Flinders Link Project: extension of the Tonsley rail line and new train station

SCAP AGENDA ITEM: 3.1.1

Application Summary	
Application No:	100/V075/18
KNET Reference:	2018/19512/01
Applicant:	Department of Planning, Transport and Infrastructure
Proposal:	Flinders Link Project: extension of the Tonsley rail line and new train station
Subject Land:	Rail corridor and adjacent land (Sturt Road, Mitchell Park and Tonsley); land parcels within Laffers Triangle (Laffer Drive and Sturt Road, Bedford Park); and land parcels within Flinders University (Sturt Road and Main South Road, Bedford Park)
Relevant Authority:	Minister for Planning
Role of the Commission:	Section 49(7) & 7(c): the State Commission Assessment Panel must undertake an assessment of the proposal and report to the Minister for Planning.
Zone / Policy Area:	Regional Activity Zone and Residential Zone [PA12: Medium Density, PA16: Regeneration]
Categorisation:	Merit
Notification:	Yes - development cost exceeds \$4m
Representations:	Four (4)
Lodgement Date:	11 September 2018

CAD FILE NAME: CS1-DRG-352329.DWG PLOTTED: Thursday, 30 August 2018 1:38:41 PM

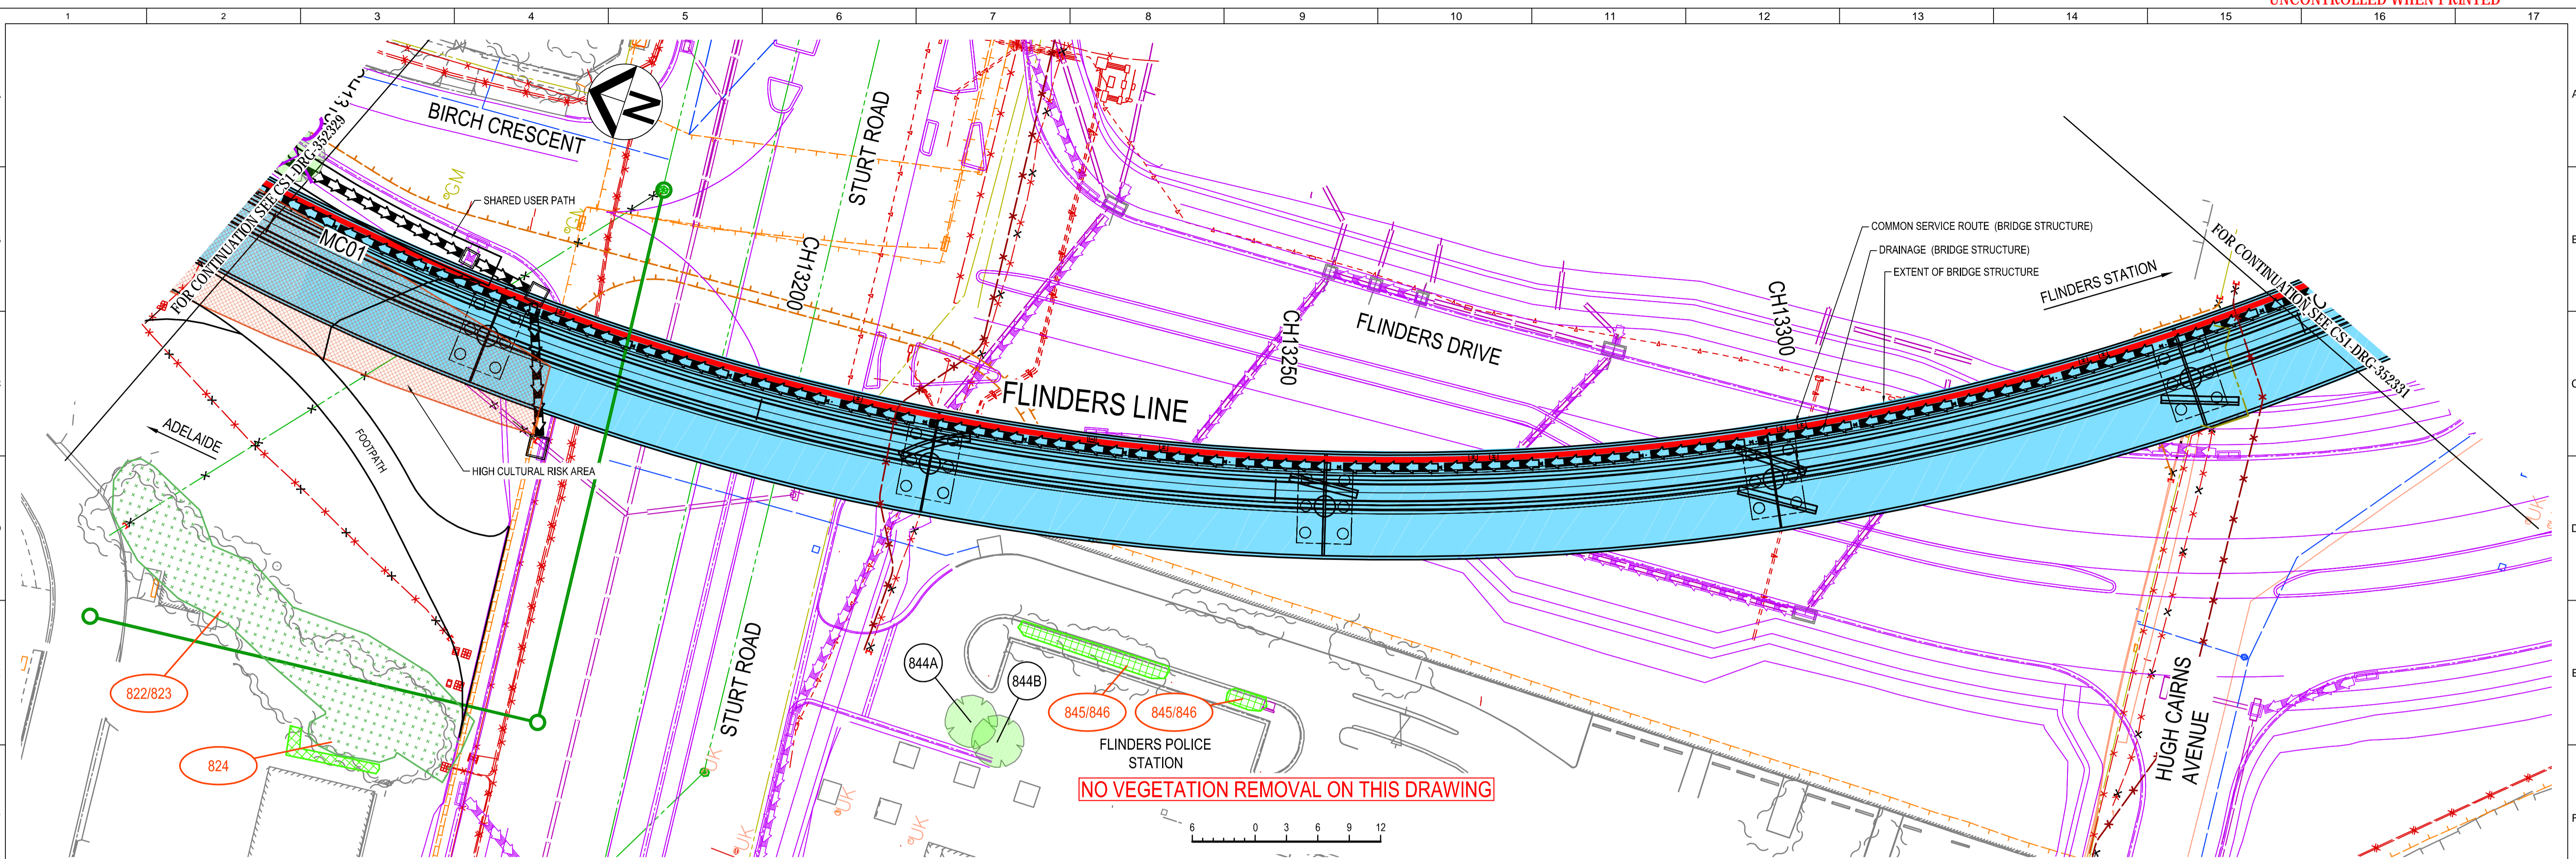
- Opportunity to minimise impacts to amenity trees 803A to 806D (Elm Trees), removal status is '?' on Drawing 352329, and note is provided regarding discussion required on site to minimise impacts to these trees. Relates to need for retaining wall if trees are retained and whether there is enough space for retaining wall. GWS have suggested it is likely these trees can be retained and that any removal will constitute a HOLD POINT to be released.
